Dear Design Review Commission,

The proposed new second story rear deck and windows at 1035 Ray Avenue will destroy neighbors' visual and acoustic privacy and damage the neighborhood, establishing a bad precedent. Previously, people who wanted second floor decks-balconies in our neighborhood have had to put them in the front to preserve the privacy of the neighboring properties. Only decorative balconies have been allowed in back.

## SINGLE FAMILY - DESIGN GUIDELINES - 1035 Ray Avenue Project

**Project:** 1035 Ray Ave.

**Fig 3. 1035 Ray Avenue –  
Current view from 1030 Rilma Lane**

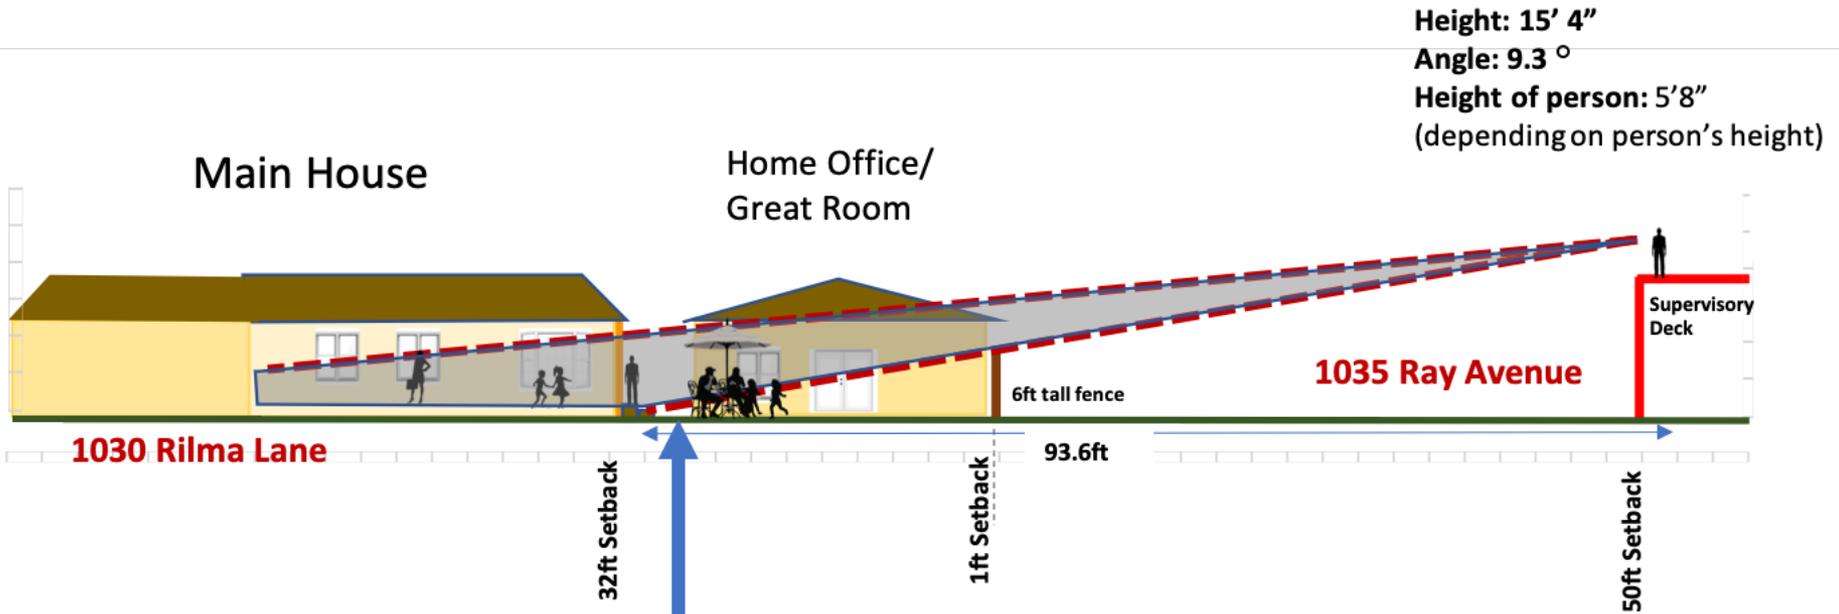
**1035 Ray Ave – Remove all site-lines & minimize Glazing**

## Fig. 5 Nighttime view from 9ft point of Sight Line

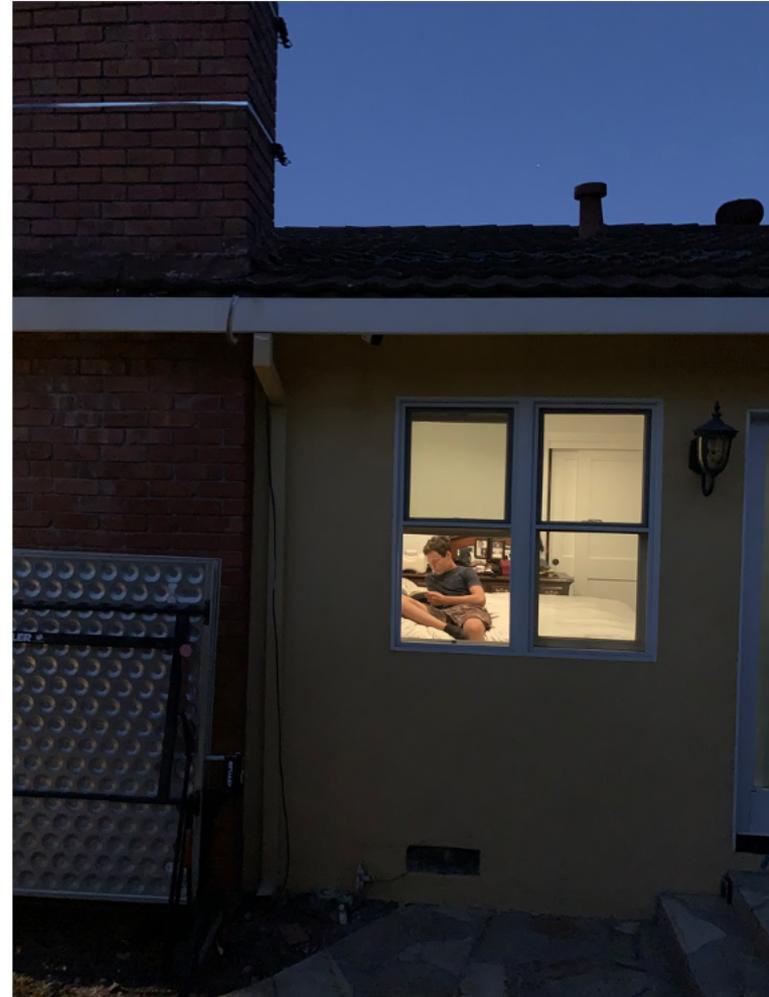
No air-conditioning open windows to cool down the house. kitchen, dining, living, and master.

### Request to Los Altos Planning 2020 (6/2/20)

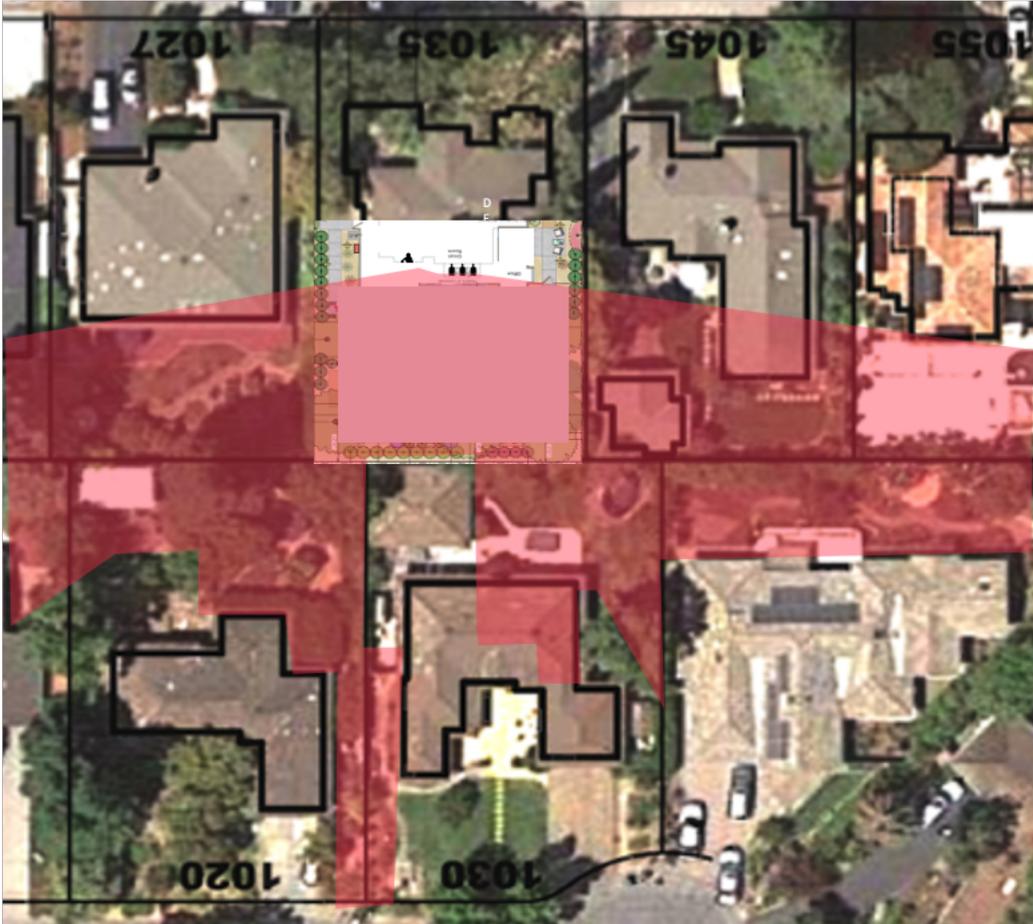
- Adequate screening is needed that does not tunnel or shadow our backyard. We do not have space for trees.

Response: Landscaping is not under the control of the planning dept. It is the decision of the applicant and their certified landscape designer.
